Response to Submissions

Westmead Catholic Community
State Significant Development Application

Submitted to Department of Planning, Industry
and Environment

On behalf of Catholic Education Diocese
Parramatta

Figure 1 Site-generated trips at existing site access (AM peak hour)

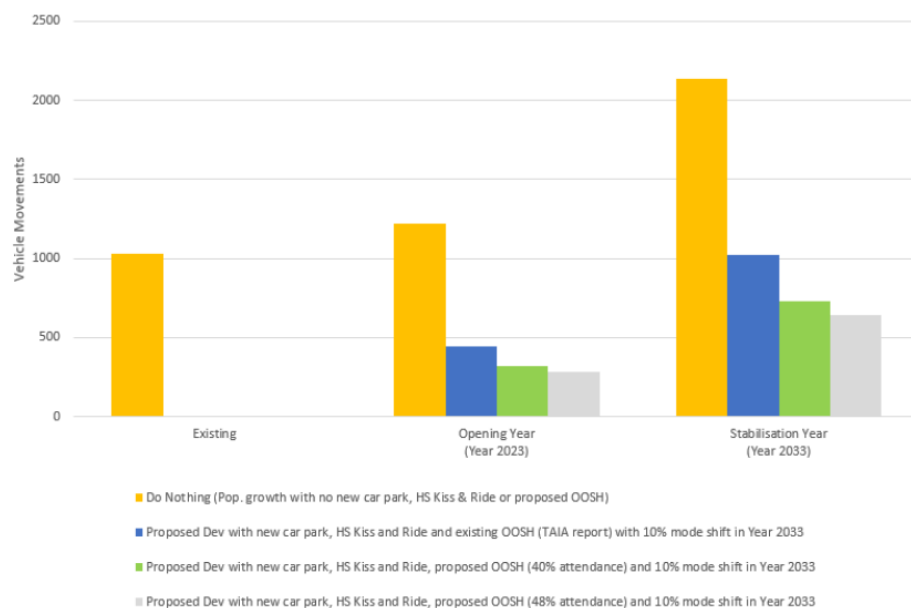
The Department and Council have raised concerns regarding traffic, access and connectivity. These matters are of particular concern for Council, and form the basis of their objection to the application. Whilst Transport for NSW did not raise any significant concerns around traffic and access, they did request that a Green Travel Plan be prepared for the project.

- Intersection performance;
- Pedestrian safety at the site's Darcy Road entry;
- The appropriateness of the site to accommodate additional students;
- The need to prepare and implement a Green Travel Plan; and
- A lack of connectivity to and through the site.

The submitted TIA did not account for the reduction in trips resulting from the operation of the Out of School Hours (OOSH) facility on the site. Given that the OOSH operates before and after standard school hours, this will result in a significant reduction in trips during school peak periods, as outlined below.

Based on the above OOSH accommodation rates, there would be a significant reduction in the number of car trips during the school peak periods. This is the result of less parents transporting students to the primary school during the peak times as they will be attending the OOSH facility.

A summary of the revised vehicle movements at the Darcy Road site access, and the reduction in movements at this entrance during the school peak periods, is provided in **Table 1**. It shows that Scenario 3 will result in a 77% reduction in the number of vehicle movements at the Darcy Road entry during the morning peak period, when compared to the ‘Do Nothing’ scenario. The reduction is shown graphically at **Figures 1** and **2**. The graphs show that in 2033 (Stabilisation Year), trip generation will be less than the existing trip generation during the AM peak period. In the PM peak period, the 2033 trip generation will be similar to the existing trip generation. As discussed below, the future trip generation modelled as part of the TIA present conservative scenarios, having consideration to transport initiatives such as the Parramatta Light Rail, Sydney Metro West, and improved bus services.

Figure 9 Year 5 and Year 6 learning and play areas

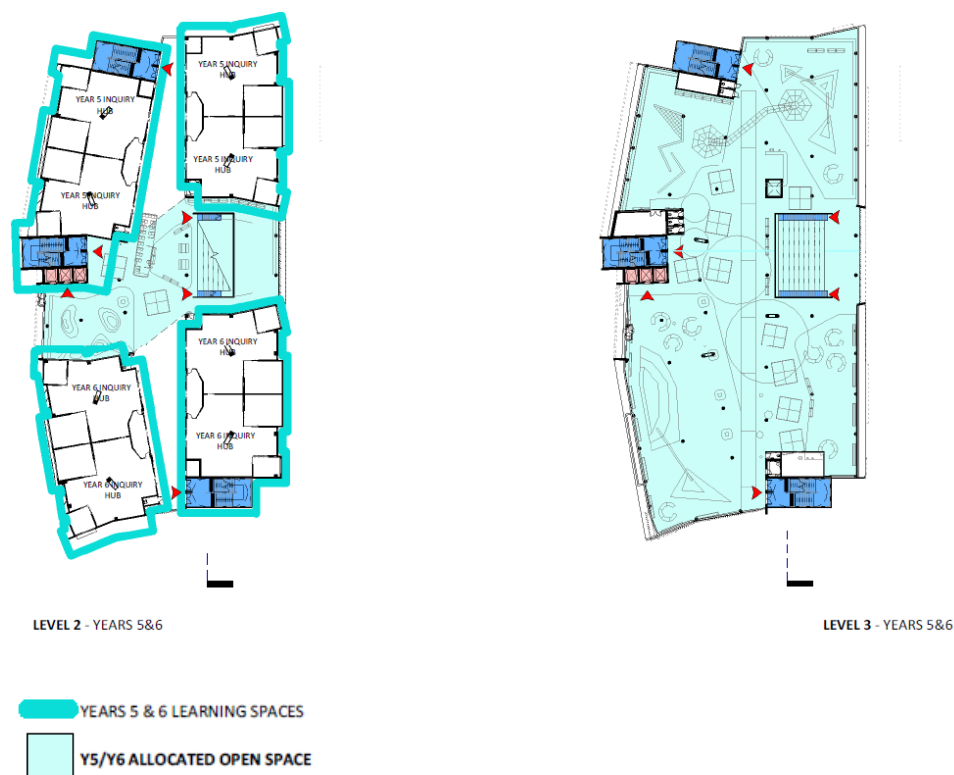
Both the Department and Council have raised concerns regarding the proposed open space, both in terms of the design and use of the space and the quantity of space provided. Their comments can be summarised as follows:

- The need for more open space at ground level, noting the unconstrained nature of the site;
- The quantity of open space provided within the building, as well as across the site;
- Inclusion of circulation areas in between classrooms in open space calculations;
- The reduction in the availability of open space and active recreation opportunities, including the loss of the junior sports field and the reduction of multi-use courts; and
- The identified lack of sporting fields and active recreation facilities in the surrounding area, with Council noting that they are unable to accommodate any increased demand created by the reduced open space and active recreational facilities within the campus as well as the additional student population.

To demonstrate these spatial relationships, a series of diagrams have been prepared to show the distribution of the primary school population within the building and circulation/proximity to open space (refer to **Figures 7 – 9** and **Appendix B**). In summary:

Whilst these play spaces represent the primary play areas for each year group, students will have access to all levels within the building, as required to suit the curriculum and to support learning and development opportunities. As shown on the diagrams, stairs provide access between each level, with lifts providing equitable access.

Figure 12 Revised pick-up and drop-off layout

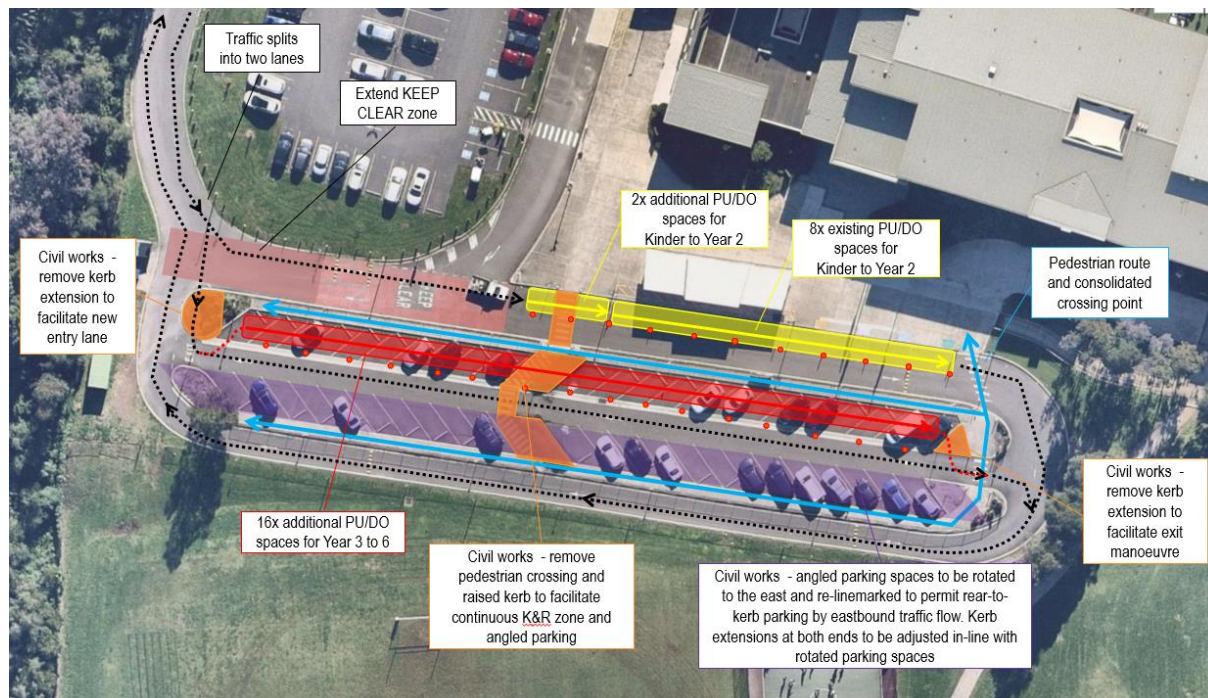
Several more detailed questions were also raised around issues such as pick-up and drop-off arrangements, use of the multi-storey car park outside of school hours, parking allocations and end of trip facilities. A response to each of these questions is provided at **Appendix A**.

The revised configuration results in the provision of 5 fewer bays – i.e. 26 drop-off/pick-up bays are now proposed, comprising 8 existing bays and 18 new bays. However, the amended layout provides a refined design with greater traffic flow efficiency and improved safety for students as it eliminates vehicles reversing into the drop-off/pick-up bays, and enables students to exit and enter vehicles on the passenger side.

The amended layout is shown at **Figure 12**. As outlined in the submitted Traffic Impact Assessment, it has been estimated that in the busiest 15-minute period in the peak hours, there would be up to 91 cars accessing the site to pick-up students (under the worst case scenario i.e. 40% OOSH accommodation scenario as calculated in the response to Submission 14 of this RTS). Based on a rate of 1 minute per vehicle as observed on-site with Council,

each drop-off/pick-up bay can accommodate 15 vehicles in 15 minutes. Therefore, the 26 bays could turnover a total of 390 cars in 15 minutes, which is considerably greater than the 91 cars that will access the site. The capacity of the amended proposal is more than sufficient to accommodate the demand generated by the future primary school (i.e. 91 cars). The drop-off and pick-up arrangement will also help maintain the short queue length for the right-turn movement on Darcy Road.
